2NRC-4-C81

June 15, 1984

SUBJECT: Beaver Valley Power Station - Unit No. 2
Docket No. 50-412
Identification of Backfit Requirement Number 4

FIG. RESPONSE 8.12(2)-3

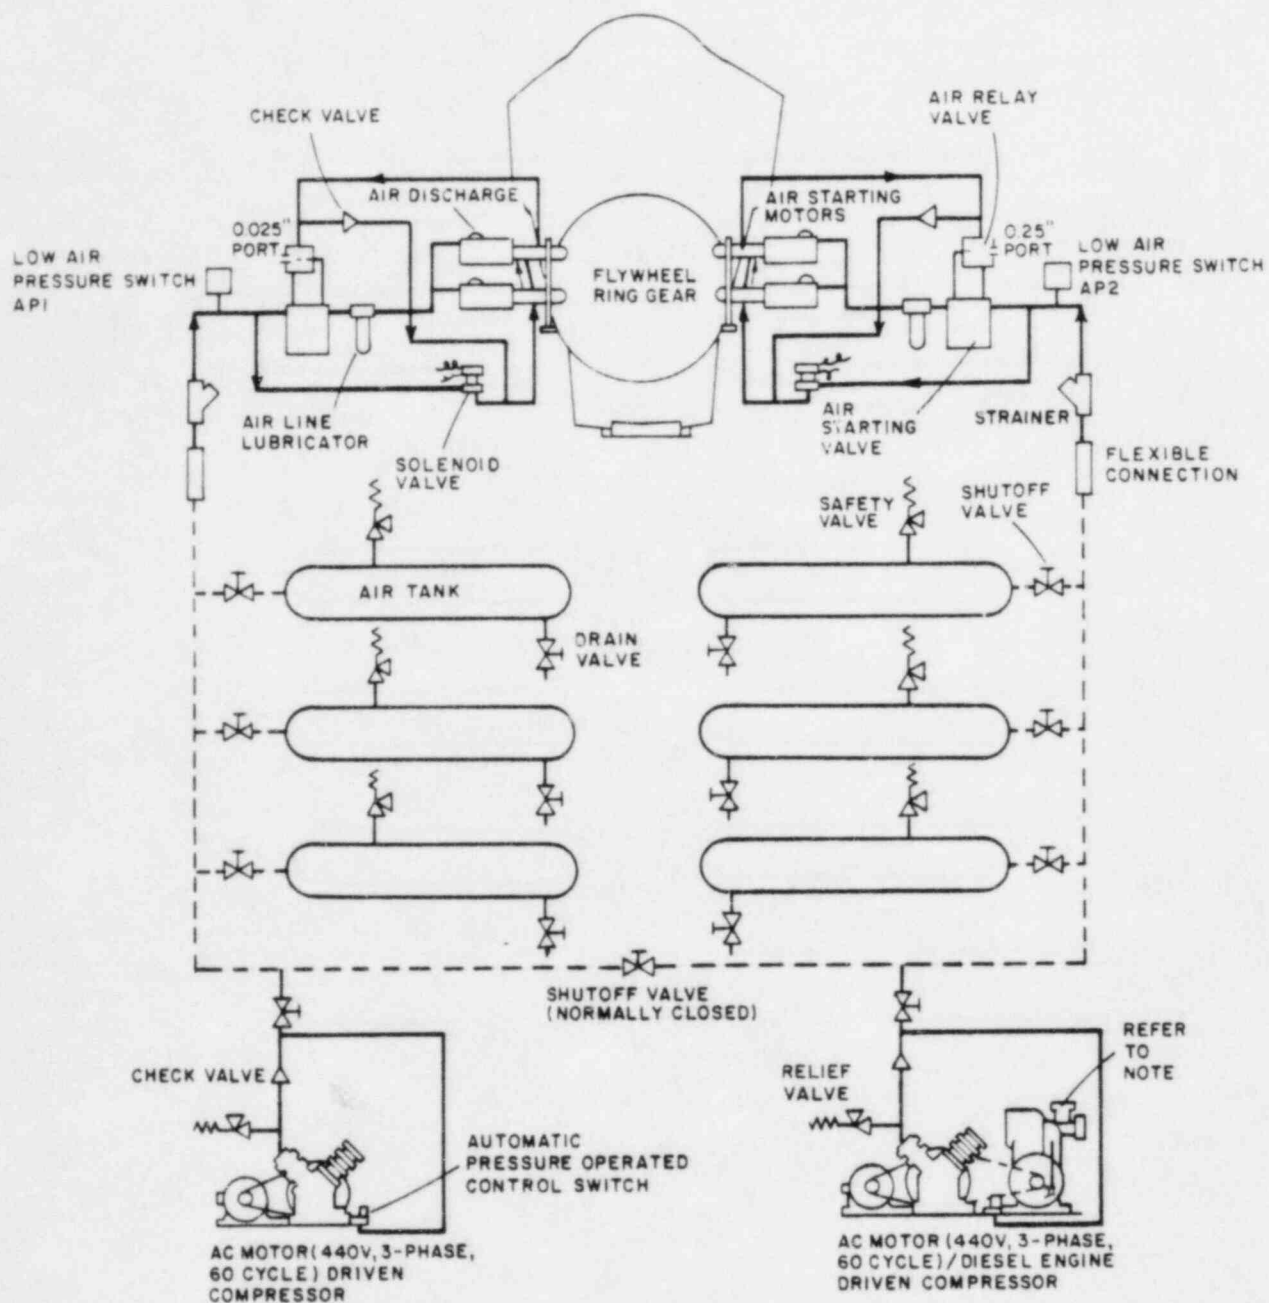
On September 19, 1983, the NRC staff issued questions 430.97 and 430.100 (Attachment 3). Question 430.100 states, "... we require that compressed air starting system designs include air dryers for the removal of entrained moisture." In this question, the NRC staff directs, "Revise your design of the diesel engine air starting system accordingly" Attachment 3 (originally Attachment 3 to DLC letter 2NRC-4-032, dated March 28, 1984) also includes the DLC responses to questions 430.97 and 430.100. In these responses DLC has appropriately addressed the technical aspects of the question. A draft copy of this response had previously been provided to the staff reviewer. In a telephone conference with DLC (February 22, 1984), the staff reviewer indicated that his concerns were not satisfied and that air dryers would be required. He cited NUREG/CR 0660, "Enhancement of On-site Emergency Diesel Generator Reliability" (the University of Dayton study referenced in question 430.100) as his basis for requiring that DLC install air dryers.

In an effort toward improving diesel engine starting reliability, we require that compressed air starting system designs include air dryers for the removal of entrained moisture. The two air dryers most commonly used are the dessicant and refrigerant types. Of these two types, the refrigerant type is the one most suited for this application and, therefore, is preferred. Starting air should be dried to a dew point of not more than 50°F when installed in a normally controlled 70°F environment, otherwise, the starting air dew point should be controlled to at least 10°F less than the lowest expected ambient temperature.

Revise your design of the diesel engine air starting system accordingly, describe this feature of your design. Also expand your FSAR to discuss the procedures that will be followed to ensure the dryers are working properly and the frequency of checking/testing (SRP 9.5.6, Parts II and III).

The University of Dayton study which concluded that water accumulation was a leading cause of diesel starting failures was based upon analysis of Licensee Event Reports (LER) issued from 1969 through 1977. Improvements in industry practices since that time, and the success of such practices must also be considered. During the first year of operation (1976-1977) at BVPS-1, two failures of the diesel generators to start because of moisture were reported via LER. To prevent further occurrences, a system of periodic blowdown as well as blowdowns prior to testing was implemented. No moisture related start failures have occurred which resulted in LER's in the seven years since (approximately 1/6 of the expected plant life). In addition, a more recent study by the Institute for Nuclear Power Operations used 450 diesel related LER's issued since January 1980 to analyze failure data. This study shows that only 5% of the more recent failures were due to moisture. Improved operation and maintenance practices applied by the industry when the moisture problem first became apparent on an industry-wide basis in the late 1970's is undoubtedly part of the reason for this improvement. Such practices at BVPS-1 have proven to be highly successful.

As described in FSAR 9.5.6, the method of starting the diesels used at BVPS-2 involves admission of air directly into the engine's cylinders. This eliminates the need for air start motors used on some other designs which are, as stated in NUREG/CR 0660, more susceptible to moisture related damage. Another important design feature which allows these diesels to be more tolerant of any starting system failure is the redundancy of the start systems. Each diesel is provided with redundant starting system components to enhance its starting reliability as stated in FSAR 9.5.6.

In accordance with GDC 17, sufficient independence and redundancy is provided to assure performance of safety functions assuming a single failure. Loss of a single diesel generator is considered in the safety analyses. As demonstrated at BVPS-1, loss of a diesel due to moisture is a rarity when appropriate operating and maintenance practices are applied. Coincident loss of both diesels due to moisture would be even less likely and is prevented in part by the independence of the air starting systems.

The use of operating procedures similar to those in use at BVPS-1 should provide diesel reliability similar to that of BVPS-1. Additionally, periodic testing will confirm the availability of the diesels. Thus, it cannot be concluded that installation of the air dryers, as requested by the NRC, would provide substantial additional protection which is required for the public health and safety. Therefore, this proposed backfit is not justified under 10CFR50.109.
